**Assessment of Six (6) Protected-Size Trees
at and adjacent to
14300 Lora Drive
Los Gatos, California**

Prepared for:
Jocelyn Shoopman, Associate Planner
Town of Los Gatos Community Development Department
110 E. Main Street
Los Gatos, CA 95030

Field Visit:
Walter Levison, Contract Town Arborist (CTA)
9/21/2020

Report by CTA
9/25/2020

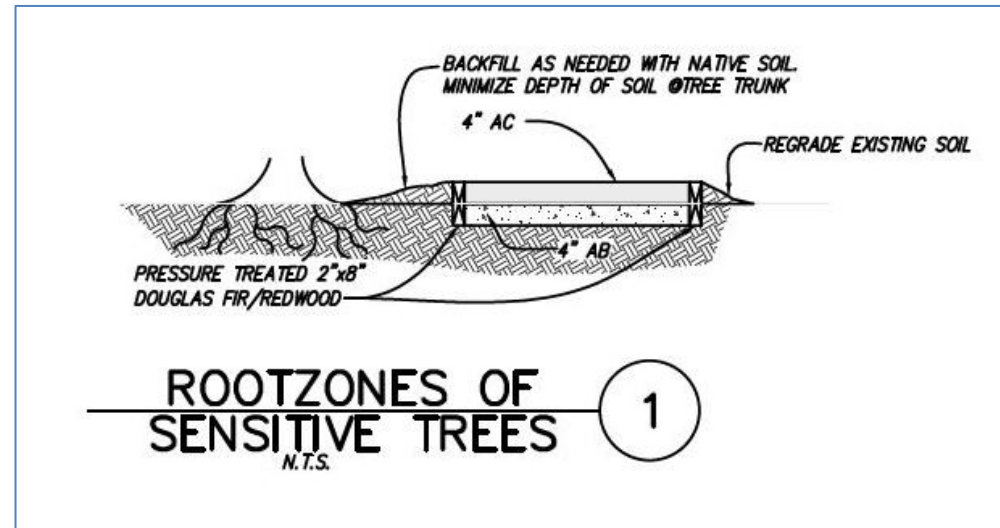
Utilize a biaxial or triaxial geogrid of high enough load rating to provide robust underlayment properties for the area roughly zero to 20 horizontal feet from **palm #42** (see CTA's tree map markup in this report, showing a yellow highlighted area indicating the zone where geogrid use may be appropriate).

Eliminate all proposed baserock base section excavation by raising elevation of the driveway, such that the geogrid is placed at existing grade (relative 0.0 feet), and the baserock base is built up above 0.0 relative grade. Build the concrete banding over grade, which will result in a total elevation change of somewhere between 6 inches and 12 inches above existing soil grade. Consult with geogrid manufacturer and/or supplier to determine how much reduction in baserock base section thickness can be achieved using the geogrid underlayment and still maintain spec load bearing properties for the driveway.

If grade elevation rise creates a trip hazard that does not conform to ADA standards, then taper the concrete banding in the area of palm #42 using soil and/or other materials to "feather out" the grade as a long taper ending at zero inches. See sketch on this page for an example.

12.0 Tree Location & Protection Fence Map Mark-up by the CTA

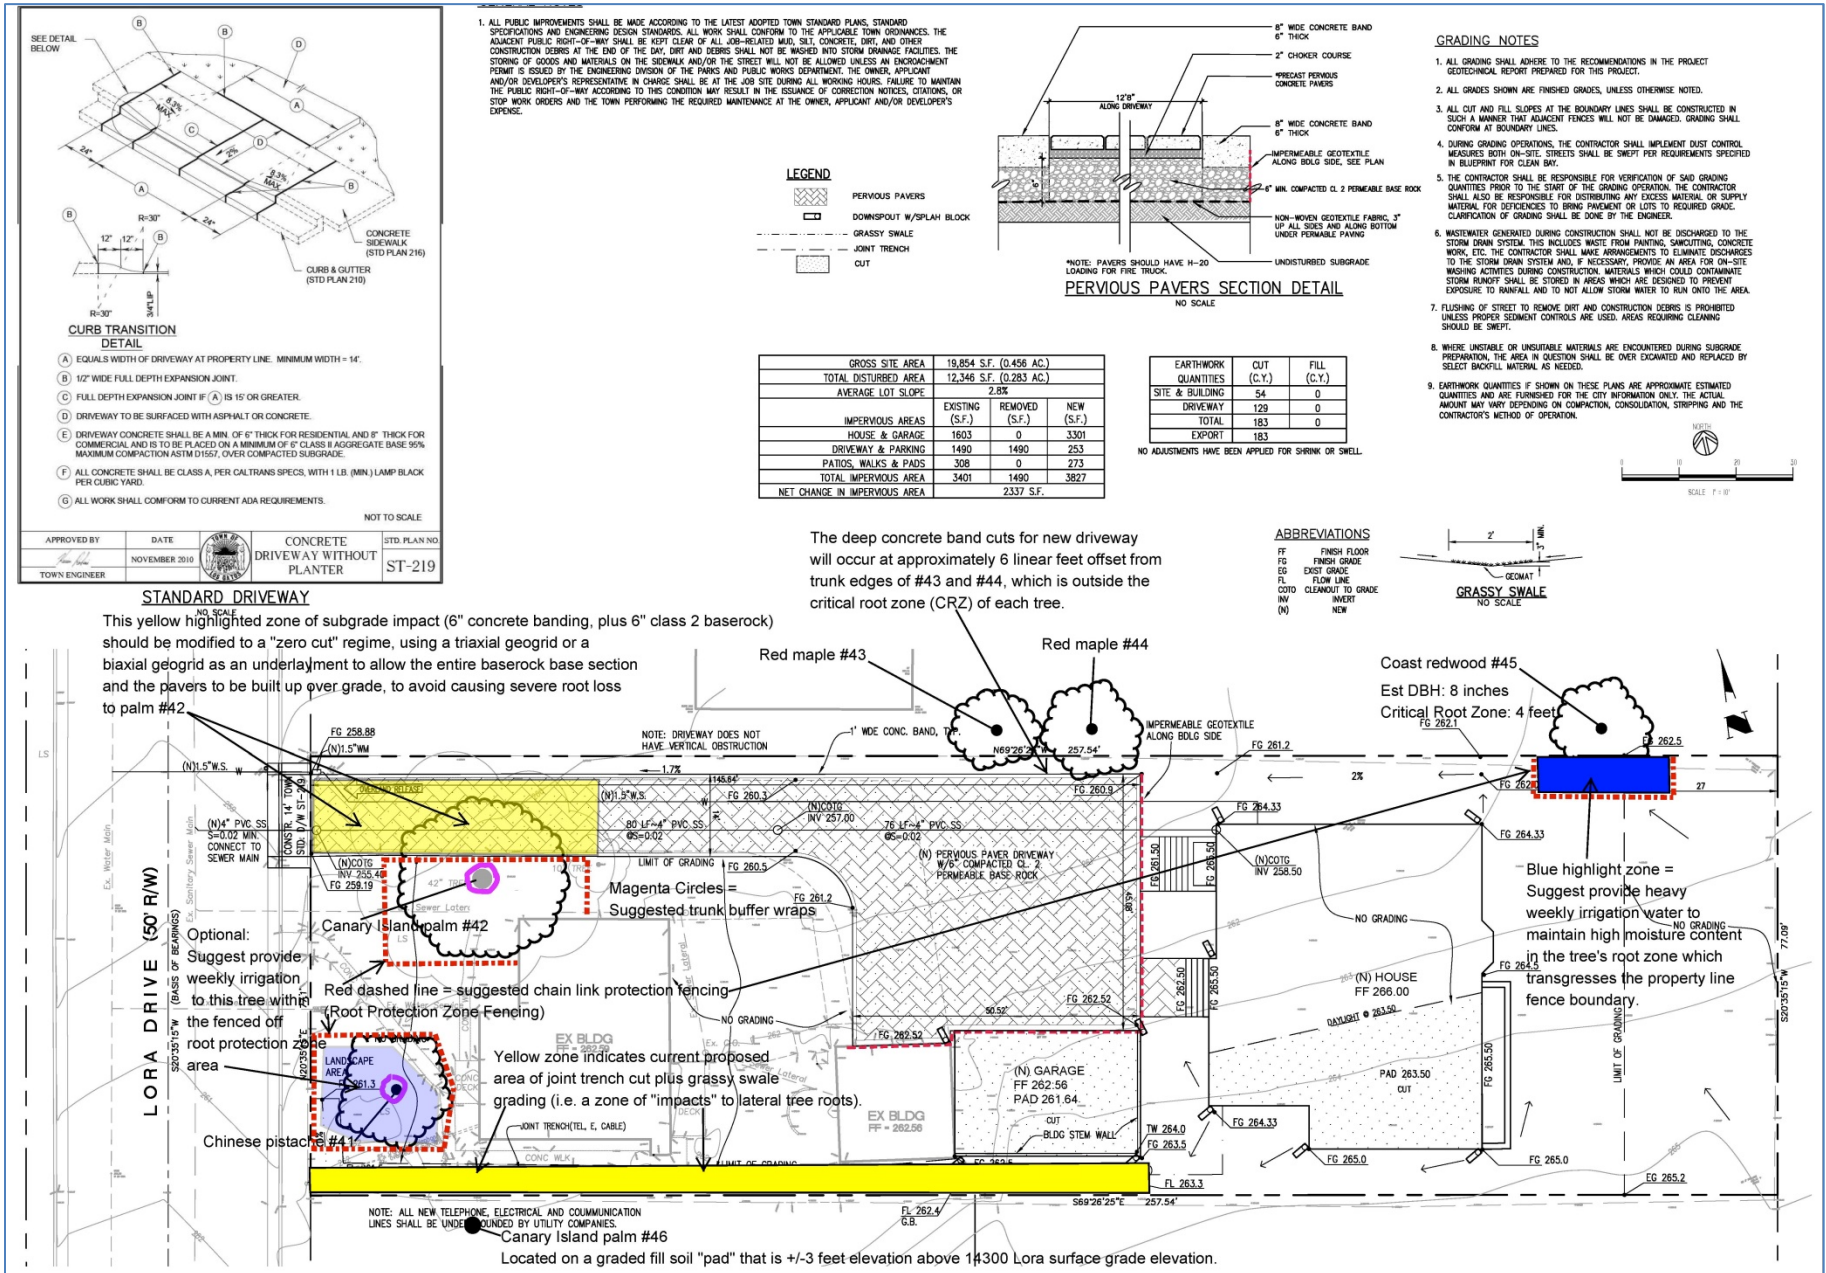
Fence off **trees #41, #42, and #45** using chain link fencing per the distances indicated as red dashed lines shown to scale on the CTA’s tree map markup below in this arborist report.

Fence routes: Per the red dashed lines indicated on the CTA's tree map markup, drawn to scale, below in this arborist report.

The CTA marked up the applicant's **grading and utility plan sheet C-1** as the background for the tree map markup.
